# SPECIAL AIRWORTHINESS INFORMATION BULLETIN

NE-06-14 December 12, 2005

Doc.-No.: SB-O-200501 Date: 18.07.2005

## **SERVICE BULLETIN**

Bartec specification see drawing below!

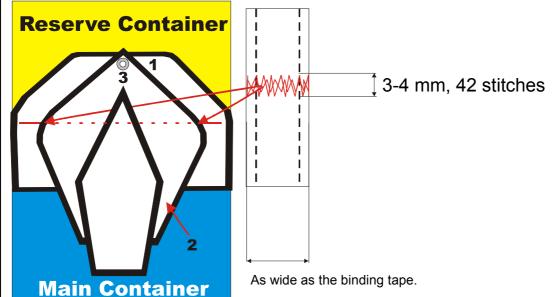
- 1. Mark out horizontal above the attachment of flap No. 3.
- 2. Put the grommets congruent on each other.
- 3. Apply a bartec (left and right) on the binding tape of flap No. 3 in the same height as the horizontal marking.

Use only Typ E / 40, Nylon Bonded thread!

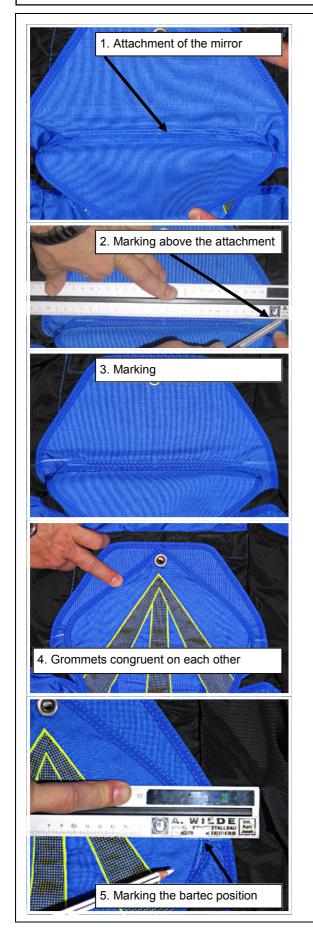
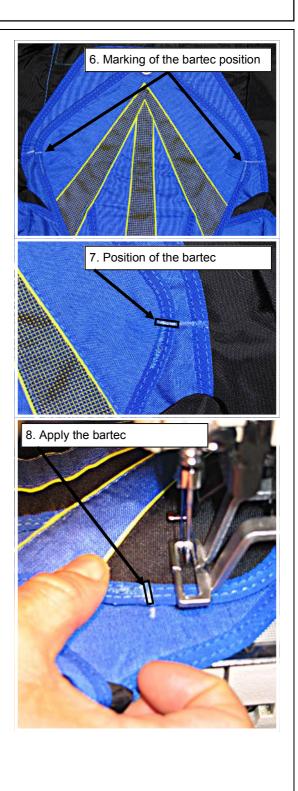
To avoid failure like written above and during improper use of the equipment in the future, the mirror (Flap No. 3 of the reserve container) must be sewed at the round corners with two short bartec to the flap No. 1 of the reserve container. This avoid contraction of the flap under tension while a line is tucked under. And it is easier to turn up the flap to release a line.
